Re: Building Recertification
600 BILTMORE WAY
Folio # 03-4117-025-0001

FORTY-YEAR INSPECTION

**Biltmore II Condominium Building
600 Biltmore Way
Coral Gables, FL 33134**

Project No. 06-269-L

PHOTO # 1: Vertical cracking on building wall located at balcony Unit #219

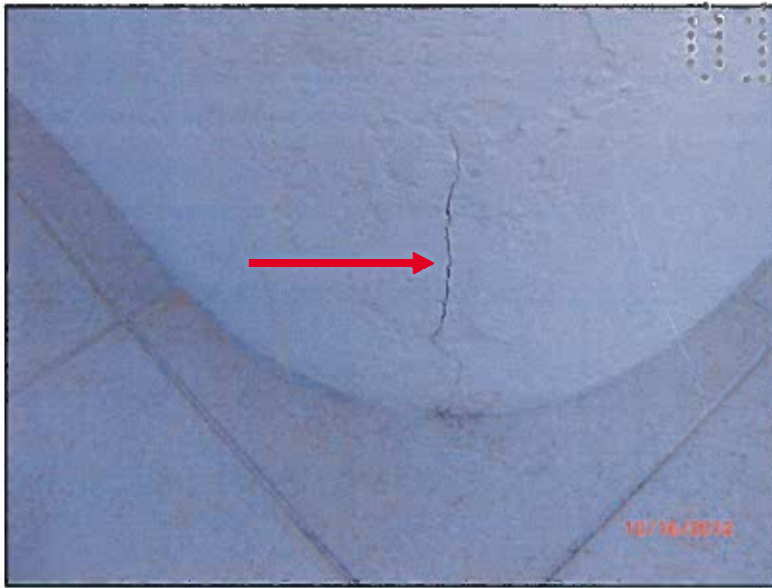
1. The building structure is generally in good condition.
2. The interior walls of balconies are in good condition overall. Minor cracking was observed on interior balcony wall and building wall (photo #1, photo #2 and photo #3) location.

PHOTO # 2: Horizontal cracking/delaminated stucco at balcony wall Unit #219

PHOTO # 3: Horizontal cracking on balcony block wall concrete cap at Unit #219

PHOTO # 4: Concrete spalling/exposed steel rebar at balcony ceiling at Unit #219

The walls of the balcony slabs are typically in good condition, the inspected residential units' exhibit cracking at balconies. This is an indication of moisture intrusion into the block wall, with subsequent delamination of stucco. If left unabated, the stucco at the balcony block wall will eventually spall off, creating a falling debris and life safety hazard for residents and pedestrians below. We recommend the balcony walls be repaired where there are sign of cracking and

PHOTO # 5: Concrete spalling at balcony ceiling at Unit #416

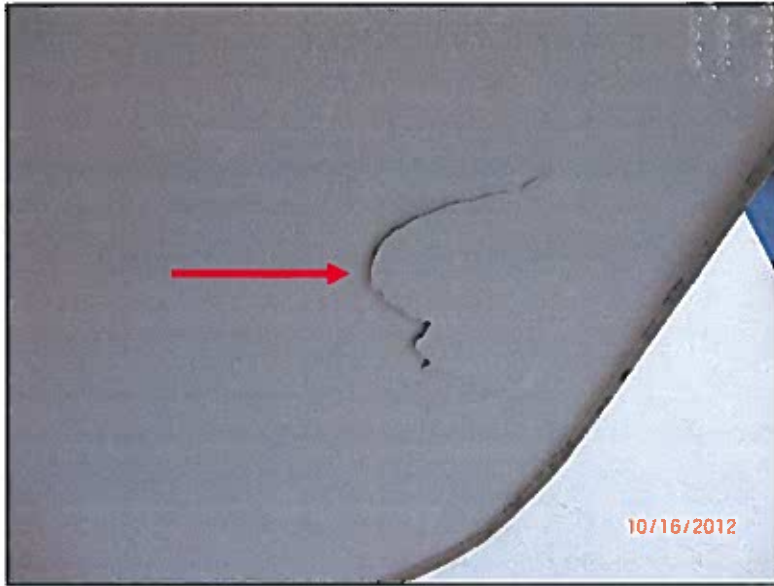
3. The balcony slabs are in fair condition. Spalled concrete with corroded reinforcing steel was noted on the balcony ceilings of Units 219 and 416 (photo #4 and photo #5).

PHOTO # 6: Cracking stucco at balcony railing connection at Unit #407

Although the edges of the balcony slabs are typically in fair condition, some units exhibit cracking and concrete spalling at the slab edge and at the underside of slab above. This is an indication of moisture intrusion into the concrete, with subsequent corrosion of the reinforcing steel. If left unabated, the concrete at the edges of balconies will eventually spall off, creating a falling debris and life safety hazard for residents and pedestrians below. It's recommended that balcony edges be repaired where there are signs of cracking and concrete spalling. In addition, we also recommend that all balconies be surveyed to document similar conditions.

PHOTO # 7: Cracking/delaminated stucco on balcony slab edge at Unit #407

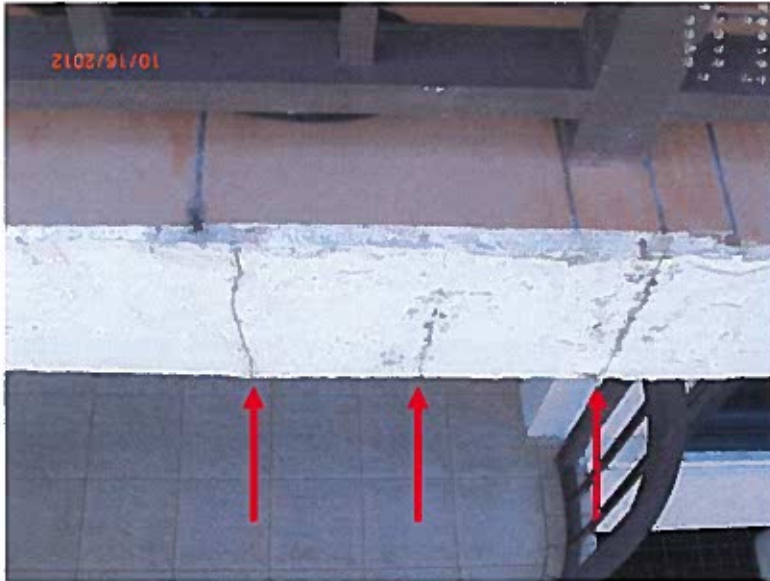
4. Minor stucco cracking at balcony railing connection to block wall of Unit 407 (photo #6).
5. We observed stucco cracking along balcony's edge of Unit 407 (photo #7) and connection between block wall and building column of Unit 219 (photo #8).

PHOTO # 8: Cracking at connection between balcony wall and bldg. column at Unit #219

PHOTO # 9: Delaminated/cracking stucco at exterior of Generator Room at roof area

PHOTO # 10: Delaminated/cracking stucco at exterior of east Elevator Machine Room at Roof Area

PHOTO # 11: Step cracking at corners of east side Elevator Machine Room

PHOTO # 12: Horizontal cracking at PH exterior wall

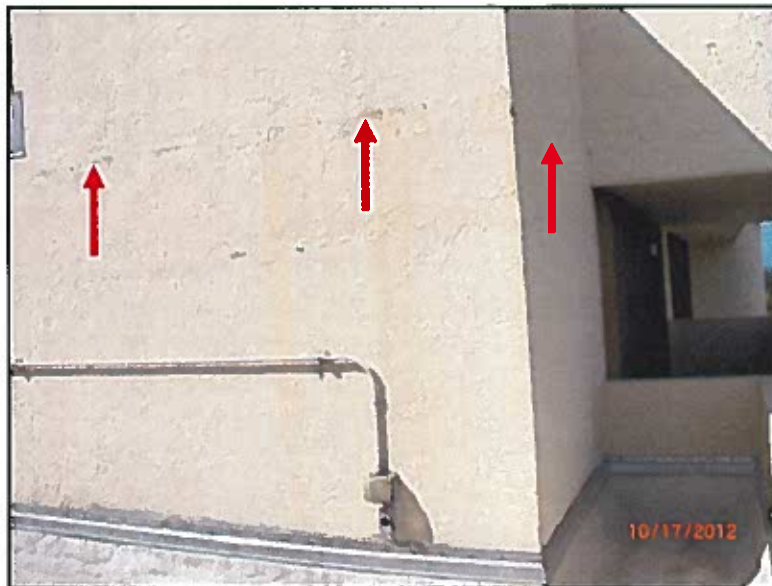
PHOTO # 13: Cracks on block wall at inside of West Elevator Machine Room

PHOTO # 14: slab cracking at column drop panel next to Parking Space No. 267

PHOTO # 15: slab cracking at column drop panel next to Parking Space No. 267

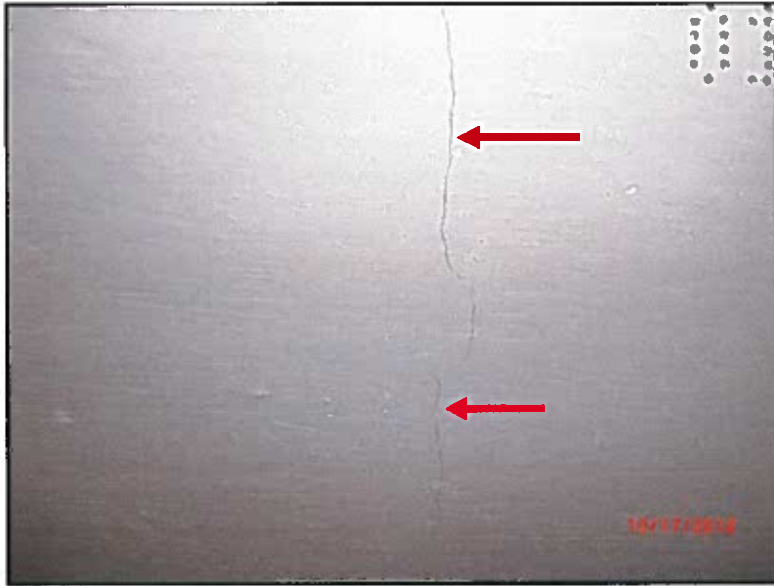
PHOTO # 16: Unsealed wall, pipe penetration at Fire rated assembly (2hr fire rated assembly)
Paint Storage Room

PHOTO # 17: slab cracking and beam cracks next to Parking Space 210

PHOTO # 18: slab cracking at column drop panel next to Parking Space 210

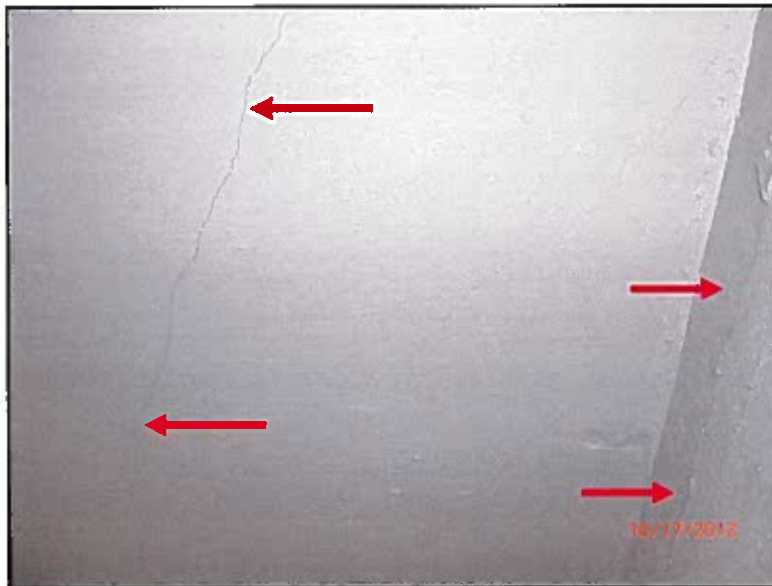
PHOTO # 19: slab cracking at column drop panel between Parking Spaces 248 & 249

PHOTO # 20: slab cracking at column drop panel between Parking Spaces 245 & 246

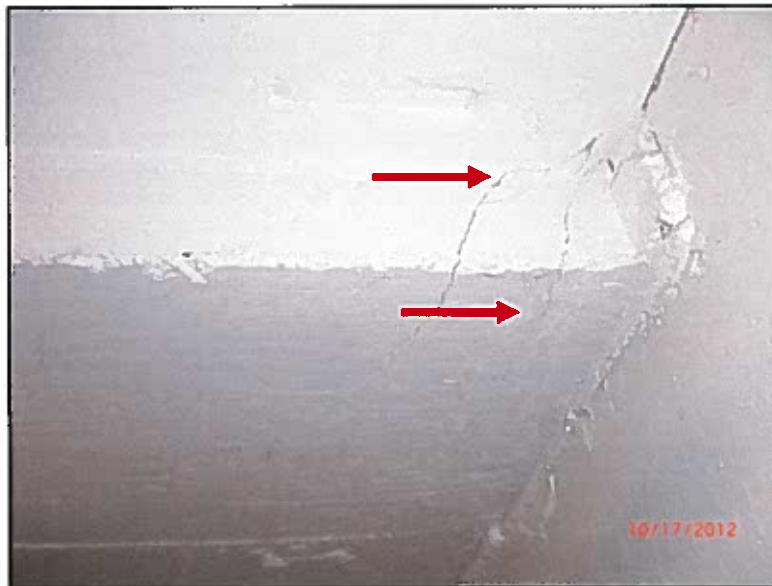
PHOTO # 21: trench drain drop ceiling between Parking Spaces 314 & 327

PHOTO # 22: trench drain drop ceiling opening between Parking Spaces 314 & 327

PHOTO # 23: cracking and water intrusion at underside of ramp in front of Parking Space 61

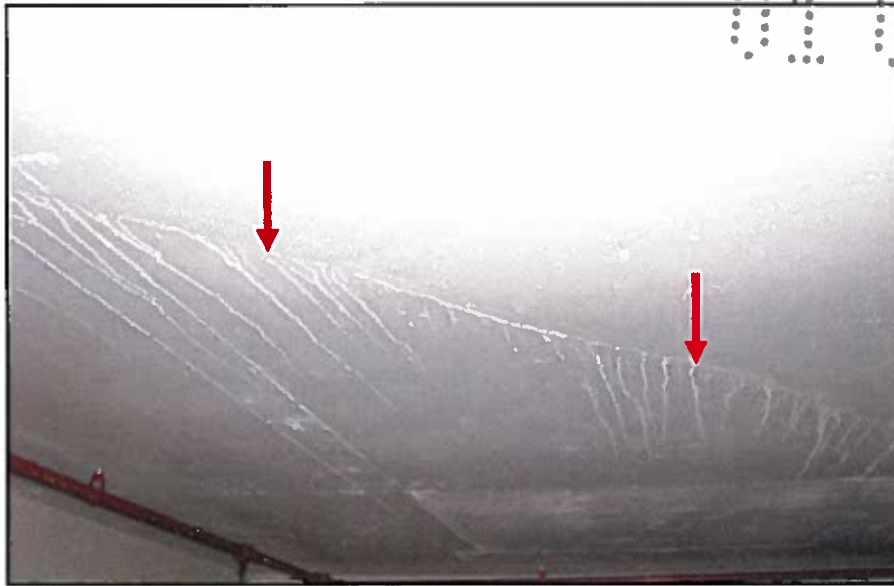
15. Trench drain drop ceiling opening over flows at opening between Parking Spaces No. 314 & 327 (photo #21 and photo #22).
16. Surface cracking and water intrusion was noted at underside of ramp on front of Parking Space No. 61 (photo #23).

PHOTO # 24: trench drain drop ceiling between Parking Spaces 52 & 61

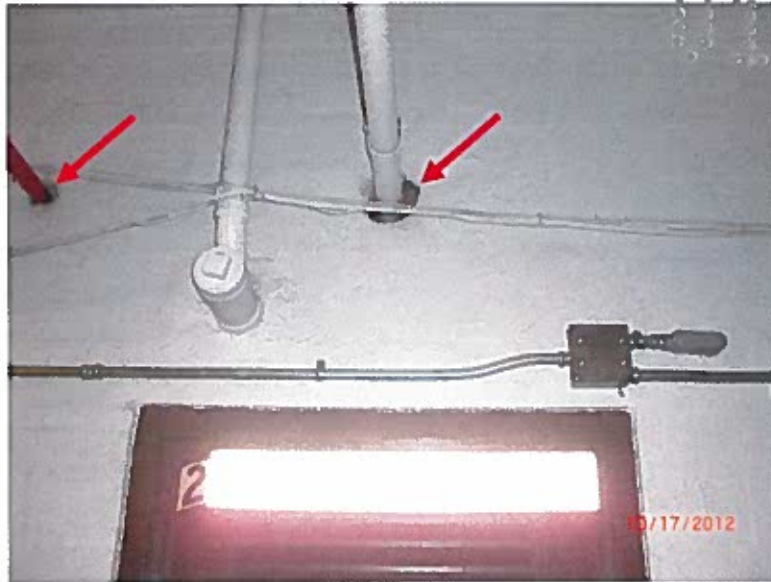
PHOTO # 25: trench drain drop ceiling between Parking Spaces 52 & 61
